Brookhaven National Laboratory
Plant Engineering - E&CS Division
Engineering Change Notice Form

PROJECT: CCWF II

ECN Title: Cooling Tower Site Plan

ECN No. 32A

PART OF DRAWING E-607

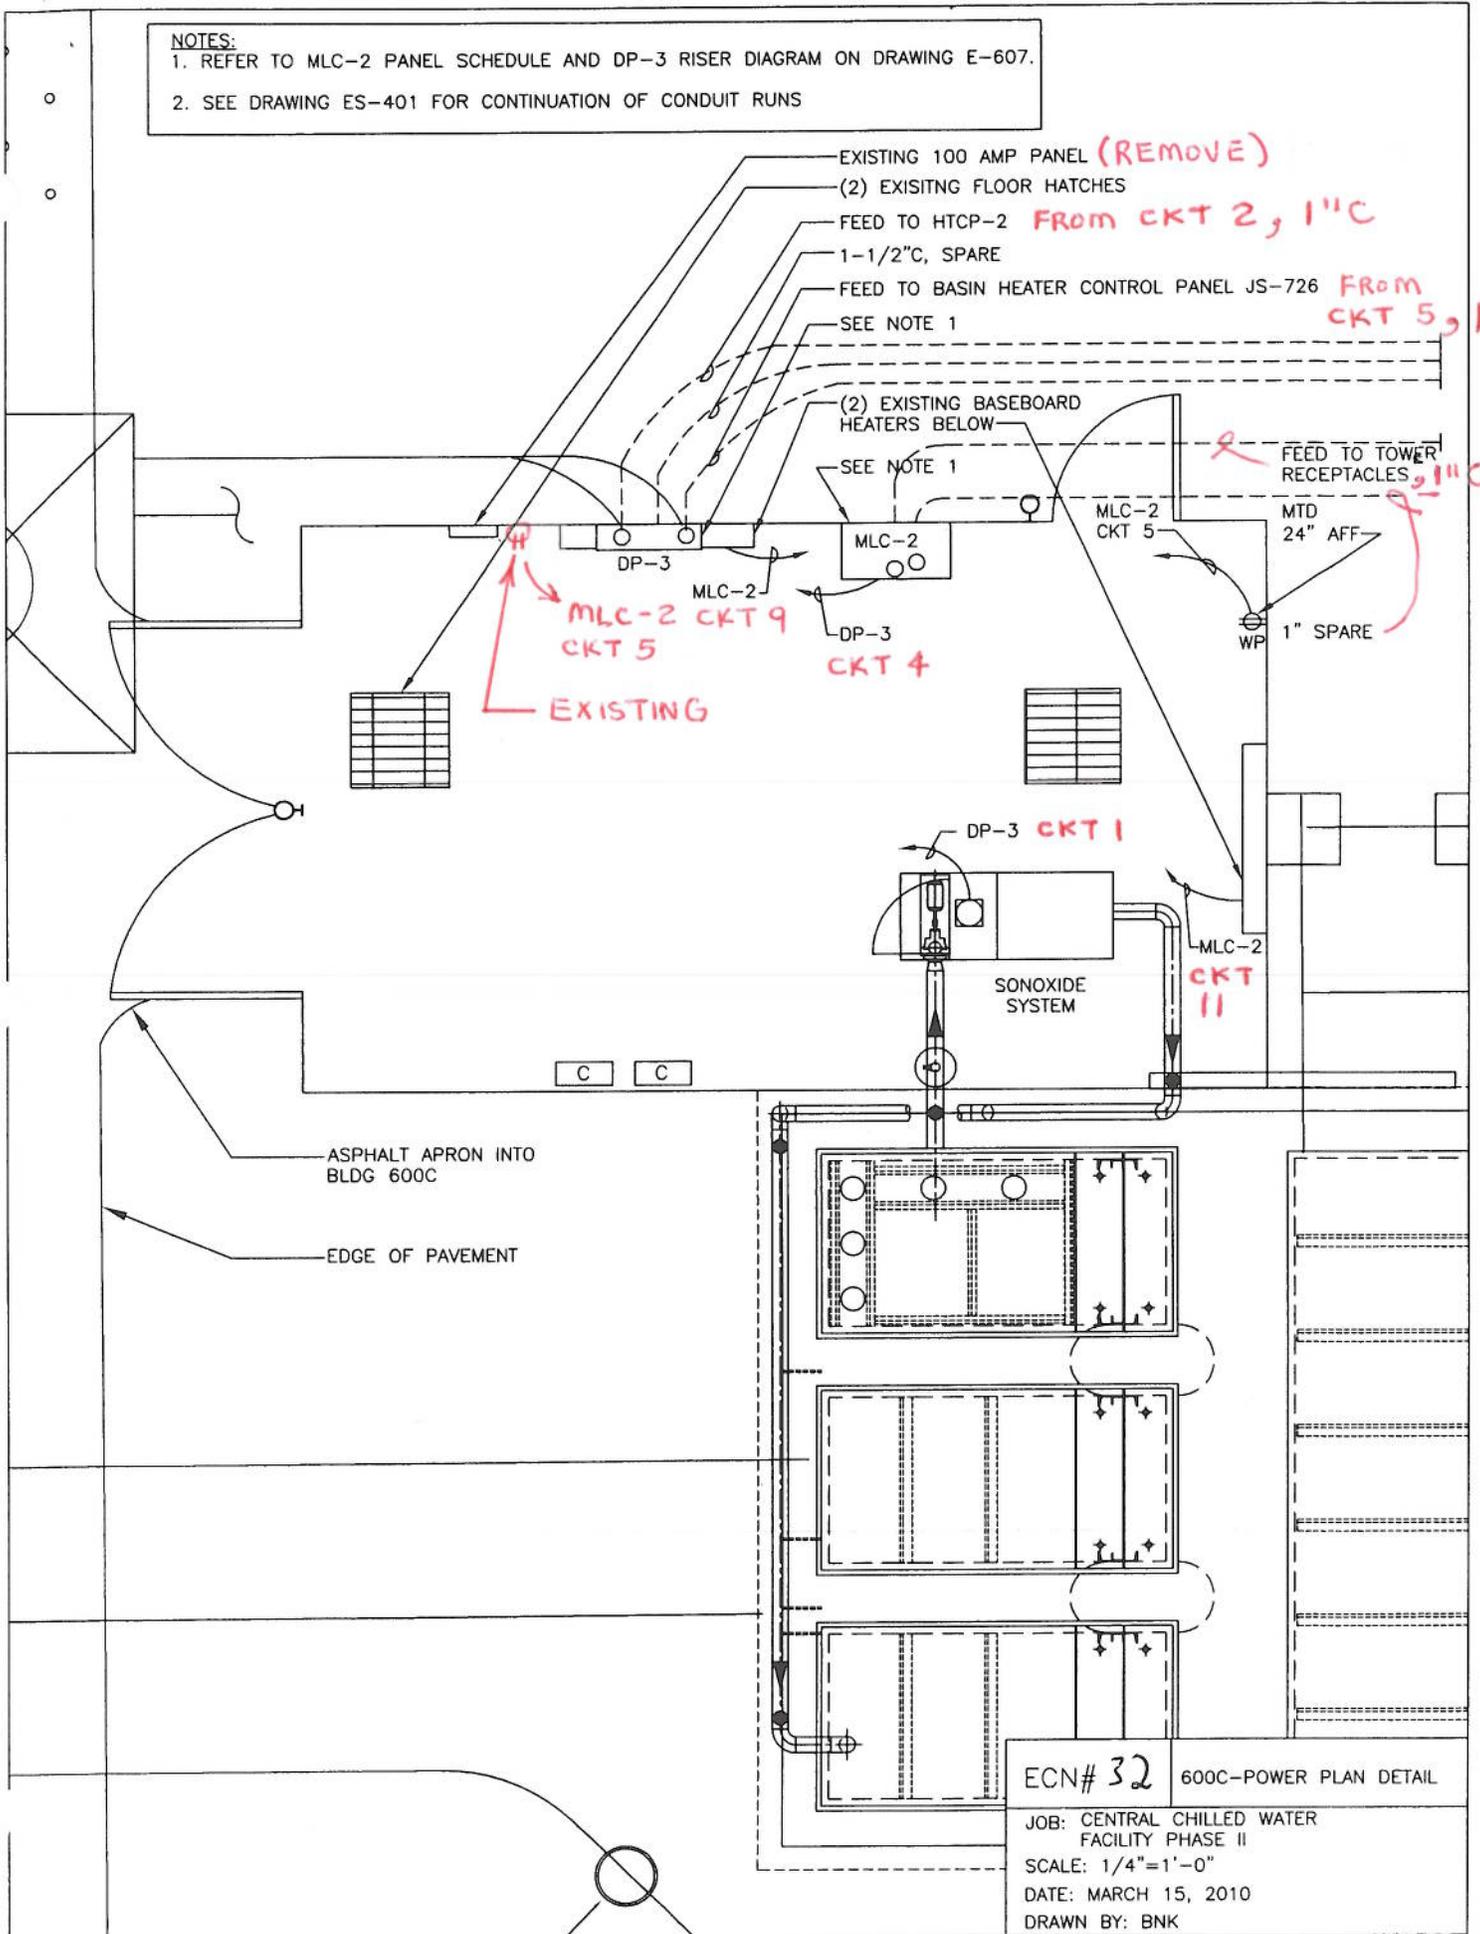
Requested Change (Attach sketch if applicable): Bldg 600C – Revise Bldg 600C (existing bldg 829) power & lighting plan details to show circuit feeds and existing 120V receptacle. Remove existing 100 amp panel. Re-wire existing 120V receptacle, lights, & heaters to new MLC-2 panel.

ECN# 32 600C-LIGHTING PLAN DETAIL

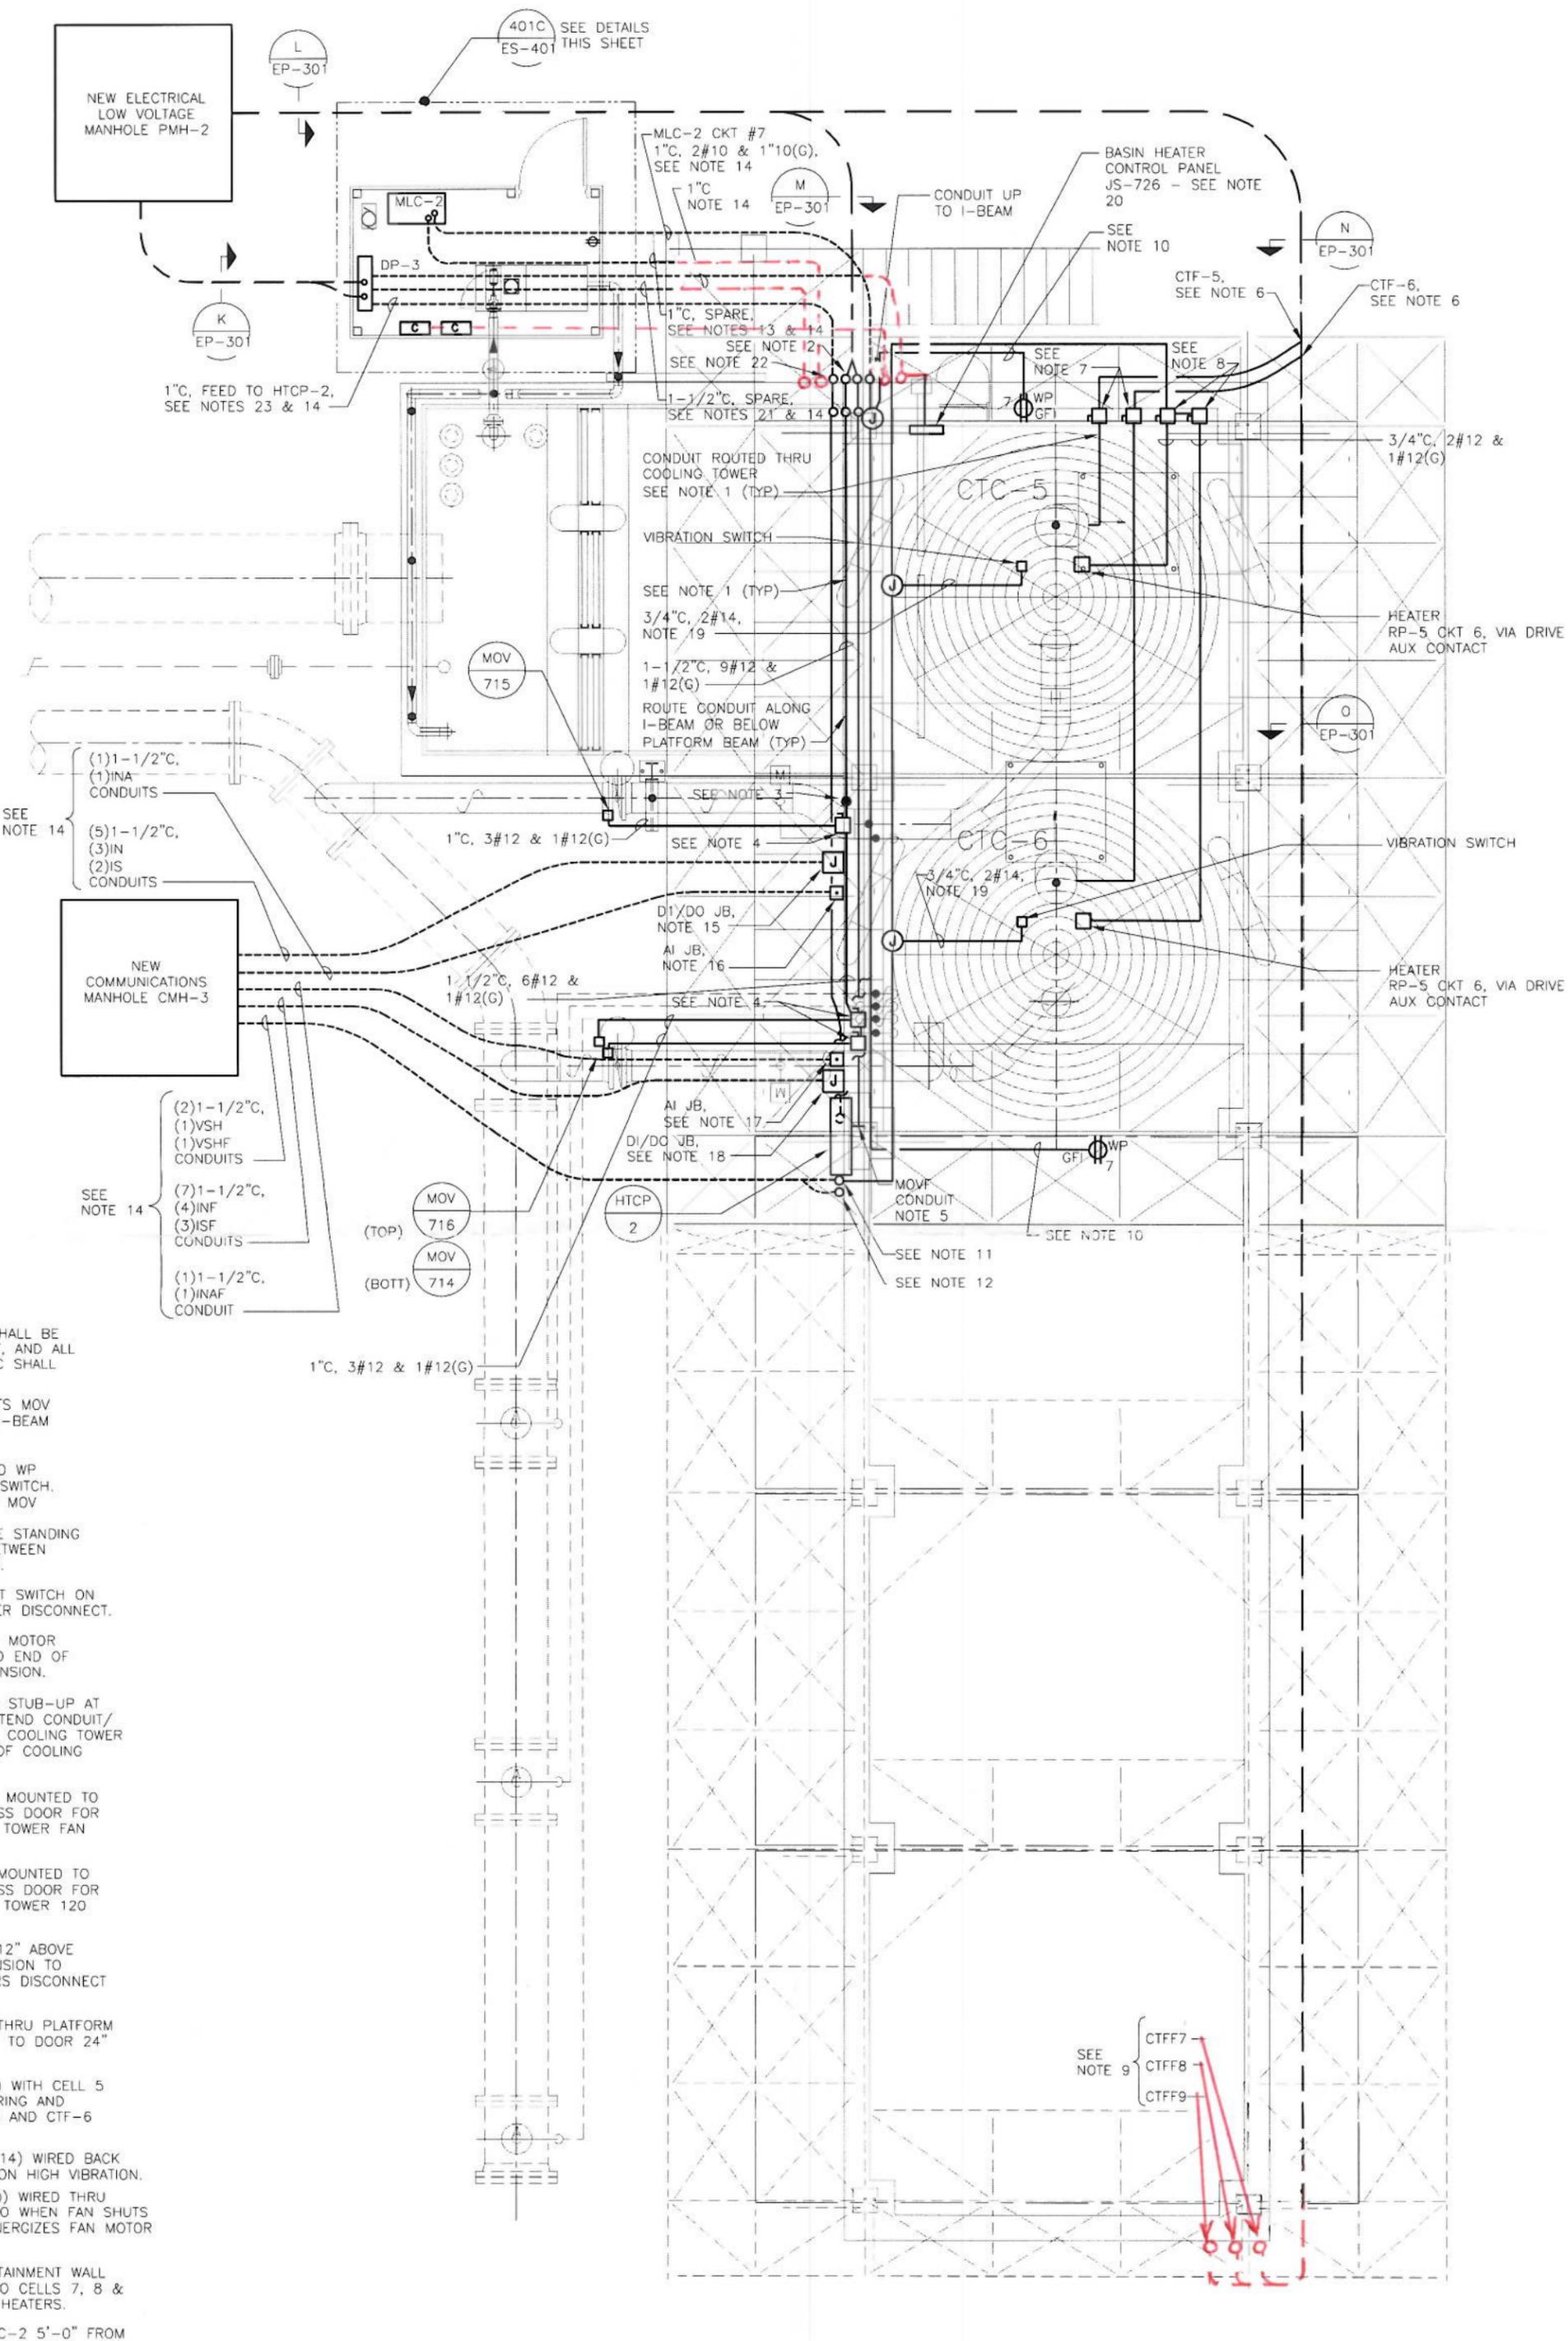
EXISTING 100 AMP PANEL (REMOVE)

Resolution: See the attached sketch

401A COOLING TOWER POWER PLAN
ES-101 SCALE 1/4" = 1'-0"

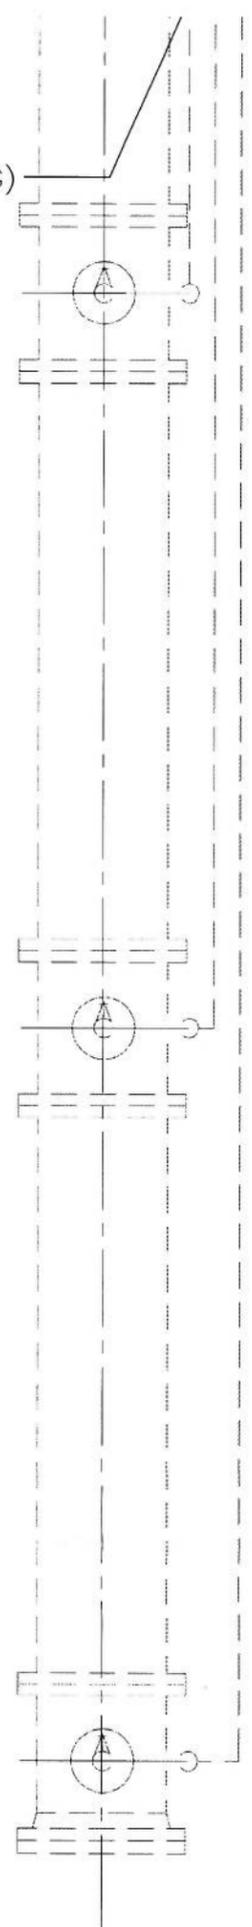
Do not peel off 1 ½” conduits for future cooling tower fan motor disconnect switches at each future cooling tower as shown on cooling tower plan sketch attached to ECN 32. Stub-up all 3 conduits on Southeast end of pier for cooling tower 9 as shown on attached sketch.

Route 1” spare conduit from panel MLC-2 and 1 ½” spare conduit from panel DP-3 underground to conduit rack at northwest pier for cooling tower 5. Stub-up conduits approximately 12” above grade and cap for future use.
